Network Working Group
Request for Comments: 1151
Updates: RFC 908

Version 2 of the Reliable Data Protocol (RDP)

RDP Header Format
Figure 1

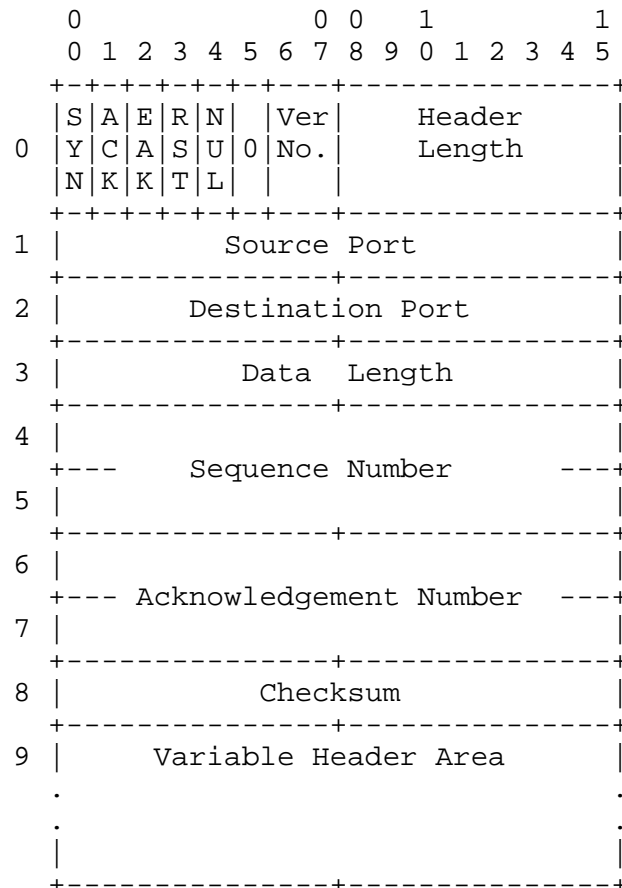
There are three changes to the protocol header: the checksum algorithm has been changed, the port size increased, and the version number incremented. The new header format is shown in Figure 1.

The major discovery during the testing of the protocol is that cost of computing the the RDP checksum proved surprisingly variable; its performance was more heavily affected by the host's data representation than anticipated. Optimized checksum implementations on two comparable hardware bases gave performance that differed by a factor of five. Since the speed of the checksum is a key factor in the performance of the protocol itself, this variation caused a noticeable difference in throughput.

The wide variation in performance on comparable machines was felt to be undesirable, so the checksum has been changed. RDP now uses the 16-bit TCP checksum, which is specified on page 16 of RFC-793.

The 8-bit port size is probably too small to support a large range of applications. Accordingly, the port size is now 16-bits. Port numbers less than 1024 are reserved for well-defined applications. Allocable ports begin at port number 1024.

Finally, because the checksum and port size have been changed, the version number has been increased to 2.
